TECHTIPS

Severe-duty QUIK-ALIGN® Pivot Bushing

In February 2020, Hendrickson Truck Commercial Vehicle Systems introduced an aftermarket severe-duty pivot bushing for PRIMAAX® EX • FIREMAAX® EX suspensions for service replacement.

12463-039 Rev A 2-23

Severe-duty Aftermarket Pivot Bushing

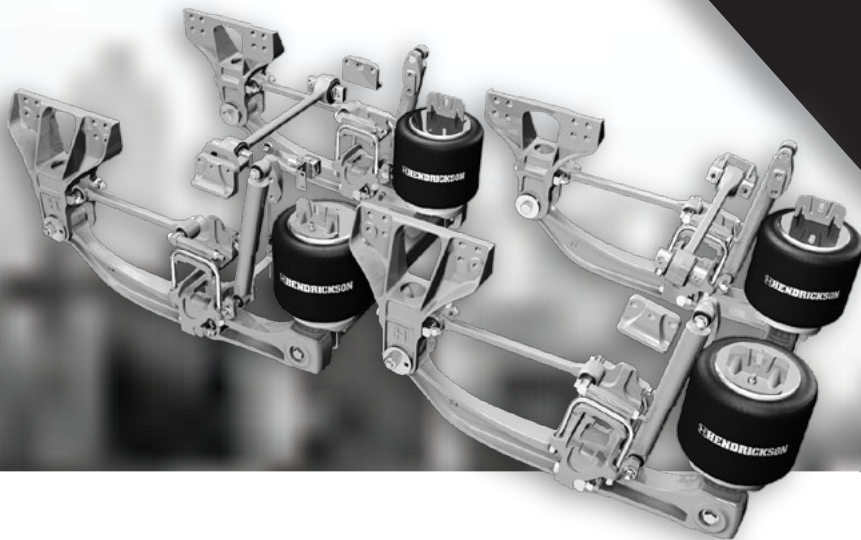
- Modified rubber bushing design enhances bushing life under severe braking, acceleration and articulation events
- Offers improved durability for severe-duty applications such as refuse, logging and oil field tankers
- The design provides up to 50% improvement in installation time
- Retains the same PRIMAAX EX • FIREMAAX EX driver comfort and performance
- Patent-pending “snap tabs” provide a snap retention feature for thrust washers to allow quick and easy installation
- Thrust washers maintain pivot bushing lateral positioning to help deliver longer bushing life and preserve pivot connection integrity
- Rubber is bonded to the inner metal which eliminates inner bushing friction greatly reducing inner bushing wear
- Increased inner metal mating surface area helps to maintain full pivot bushing clamp load and improve joint reliability

The component replacement procedure is slightly different from the standard production heavy-duty pivot bushing. Refer to the appropriate Hendrickson PRIMAAX EX • FIREMAAX EX technical publications for complete service and safety instructions available online at www.hendrickson-intl.com.

- Axle Service Kit No. 60632-043 with 1" fasteners, includes pivot bushing, thrust washers, QUIK-ALIGN collars and fasteners
